N6715A-01A

S E R V I C E N O T E

N6715A DC Power Analyzer

Intermittent power on resets and power on lock ups.

Figure 1. Demonstration of the correct placement of the clamps

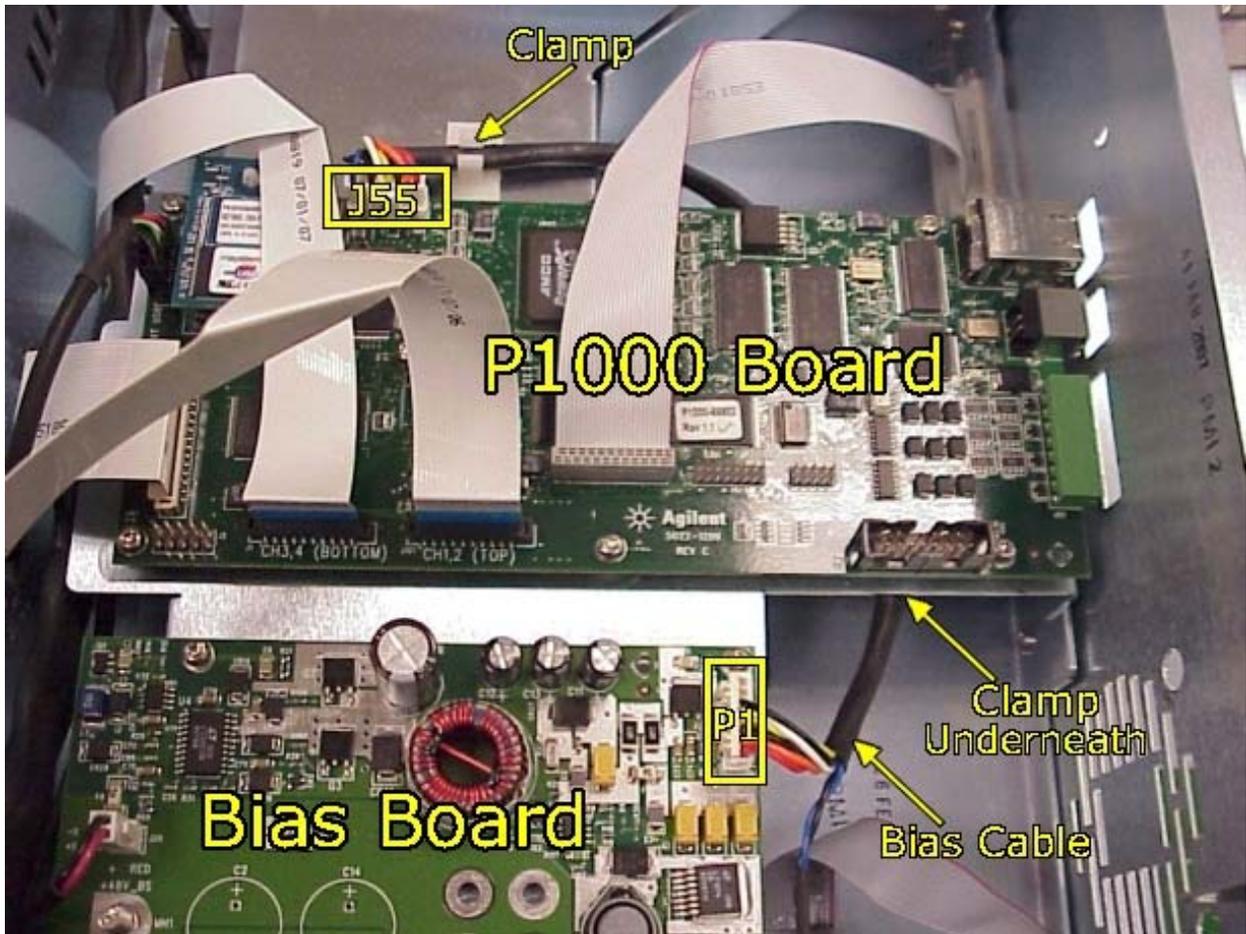
The N6715A unit is experiencing intermittent power on resets and power on lock ups. Symptoms include a white display and an unresponsive front panel with all the LEDs on. The symptoms described above will occur when there is poor or high contact resistance between the bias cable (P/N 5185-8813) and the connector J55 on the P1000 board (P/N 5022-1209) and the connector P1 on the bias board (P/N 5022-1208). The contact resistance of the bias cable and the connectors are affected due to vibration.

To eliminate the problem caused by vibration the bias cable will be secured to the chassis as shown in the following figures.

The two self-adhesive clamps are located:

1. Underneath the P1000 board on the bulk shroud. **Refer to Figure 2 for a detailed view.**
2. Next to connector J55 on the P1000 board. **Refer to Figure 3 for a detailed view.**
